ABP-313919-22
SUBMISSION ON SECTION 4 APPLICATION (STRATEGIC HOUSING DEVELOPMENT)

ABP-313919-21
Jacob's Island North SHD

RE: Application for 489 apartments and a creche at Jacob's Island, Mahon, Cork

22nd August, 2022

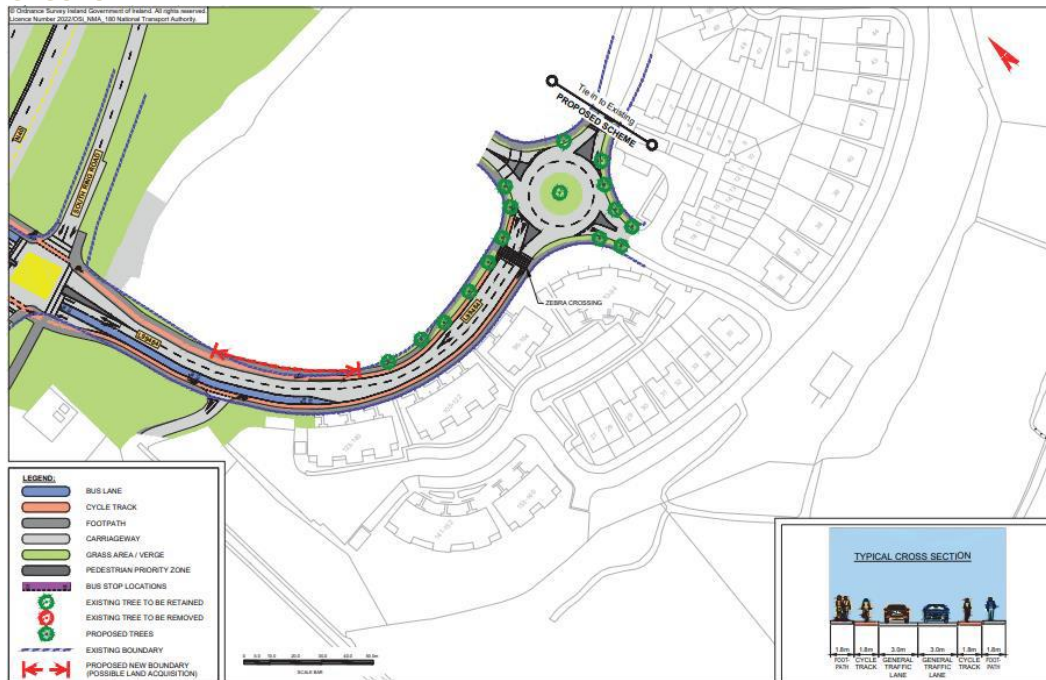
"As per the recommendations of the Quality Audit, the applicant is required to upgrade the existing crossings to cater for increased volumes of pedestrian and cyclist traffic. Prior to commencement of construction, the applicant is required to liaise with the Local Authority Traffic Operations, Road Operations & Parks and agree in writing, works required to either upgrade or provide new pedestrian/cyclist crossing facilities from the existing internal access to the Passage Greenway via the Lough Mahon walkway. Furthermore, the applicant is required to agree in writing with the Local Authority Traffic Operations & Road Operations the measures required by the applicant to substantially enhance priority and route for pedestrians to access from the development to the Mahon SC.

All recommendations to be implemented as part of the development."

Proposed Watermain Layout

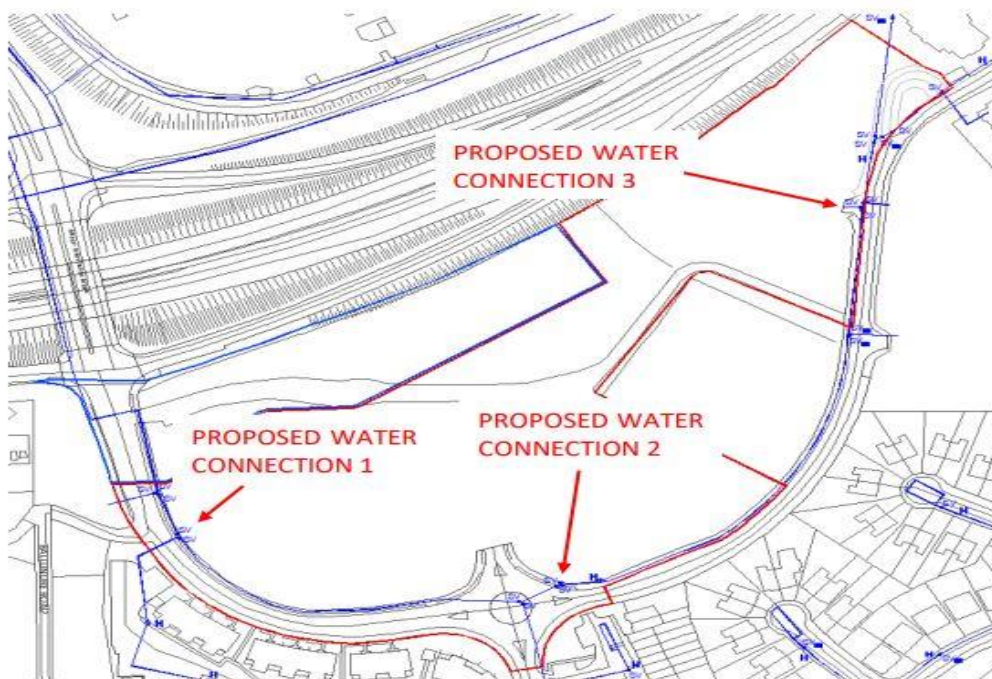
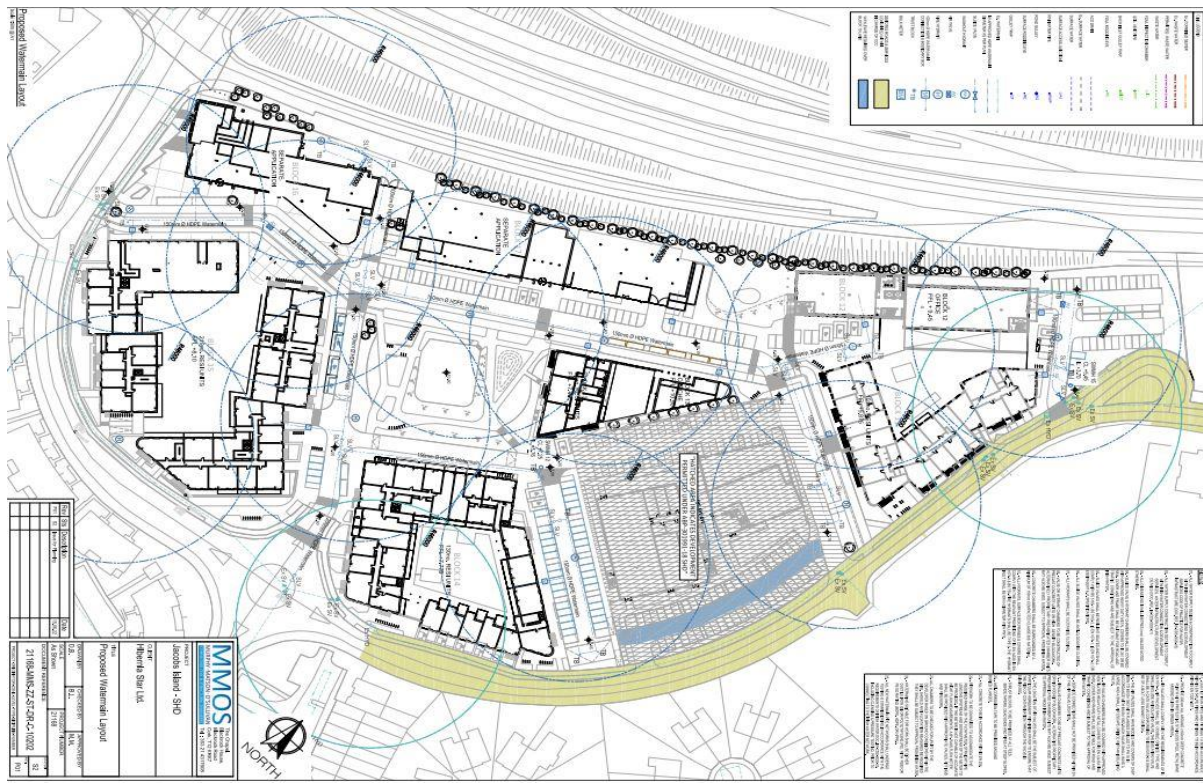
3. A revised proposed watermain layout drawing is to be submitted at connection application stage following discussions with the City Council water staff on behalf of Irish Water. The drawing shall show a revised internal layout as agreed with the water section with a minimum of two connection points to the existing 200mm water on the public footpath to ensure security of supply. As well as showing the distribution network associated with this development. It will also show the existing supply disconnections associated with this site.

4. The existing 200mm water main passes through the northern corner of the site in a North / South direction. The existing watermain should be located and marked on the ground before any works commences on site. A drawing shall be submitted showing the location of the existing water main with meters, valves and other fittings and the distance from the proposed structure, also showing any existing wayleave over the main shall be submitted to Irish Water before work commences.

5. If a wayleave is required the following condition shall apply. A wayleave width to be agreed with Irish Water shall be placed over the existing 200mm watermain and shall be ceded by the developer to Irish Water. No structure shall be constructed within 5 metres of this watermain. No planting to be carried out in the wayleave area. The applicant shall be responsible for the protection of the watermain during the course of the work.

6. The applicant shall obtain pressure and flow tests on the water network to facilitate the network design and provide to Cork City Council / IW.
7. Private watermain shall be located in private property
